# PlanGrid Task Report - Sep 9, 2024

Prepared by Stephen Tassinaro

Sep 9, 2024

## #466 [UNIT 999] - RTU Alarms Present

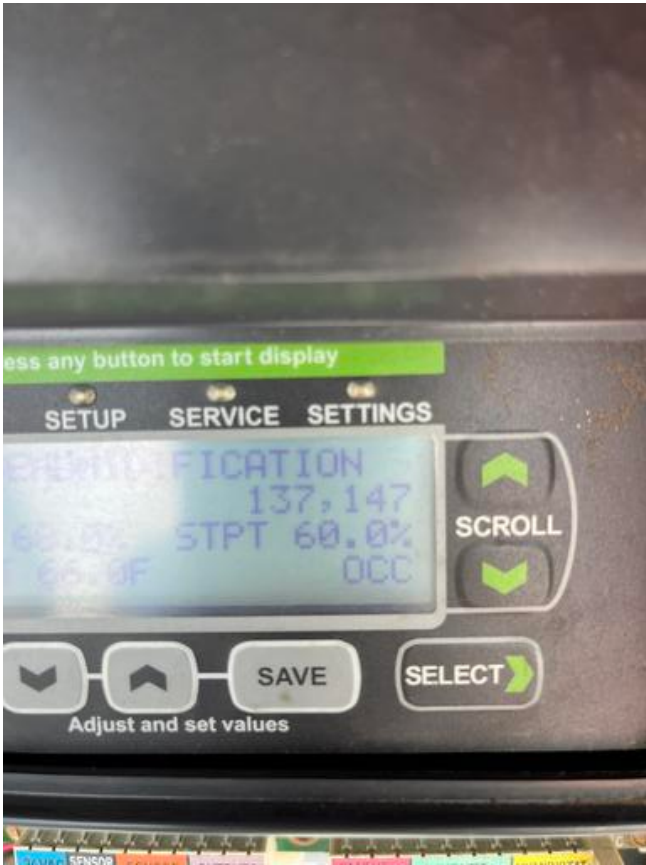
The following alarms were found on the RTUs:  
RTU 3 - Alarm 147 & 137

No active alarms on RTU's 1,3,4

RTU #3 alarming 137 & 147. Economizer functioning correctly and at NTi setpoint.

**Sheet**  
M4.2

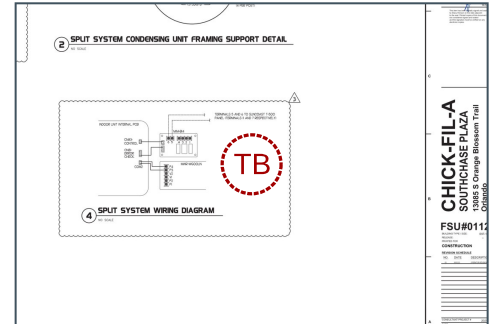
**Description**  
Mini split control wires not landed in suncoast panel.

No wires landed 6/19

No wires landed 9/9

## #412 [CNTL 508] [NEW] Controls labeling.

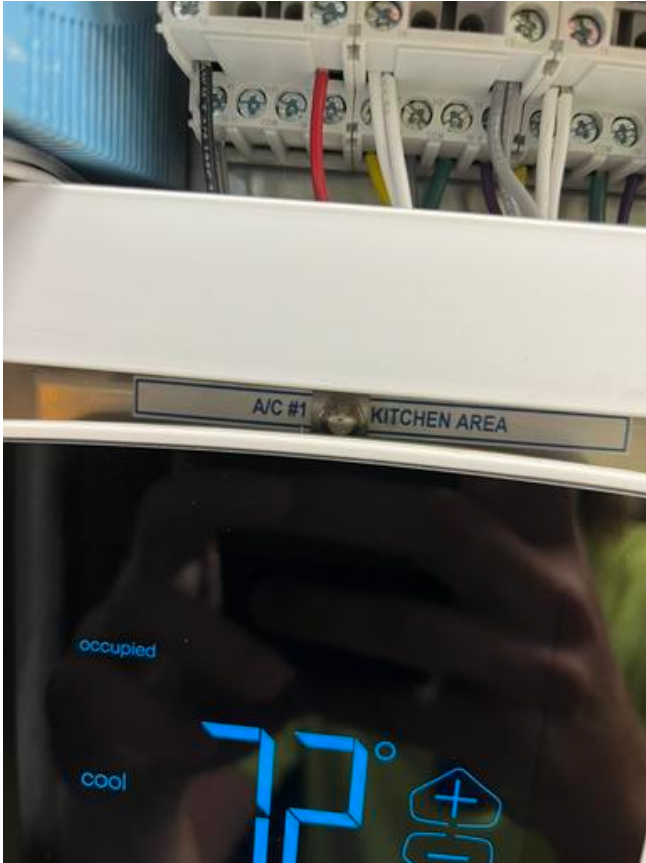
Label all sensors, humidistats, thermostats, smoke annunciators and remote space mounted OADs, MODs, VFD's for which piece of equipment they serve. Remote sensors labeled incorrectly (wrong units). Thermostats 1 and 2 labeled incorrectly (switch labels).

All sensors are now labeled but the label numbering does not match the mechanical plans. Per the mechanical plans: RTU 1 - Side Dining, RTU 2 - Kitchen, RTU 3 - Dining "B", RTU 4 - Dining "B" (where playroom previously existed).

Thermostat labeling not corrected. RTU 1 serves the side dining and RTU 2 serves the kitchen, per the mechanical plans.

See above comments. Sensors are labeled, but labeling does not match the mechanical plans.
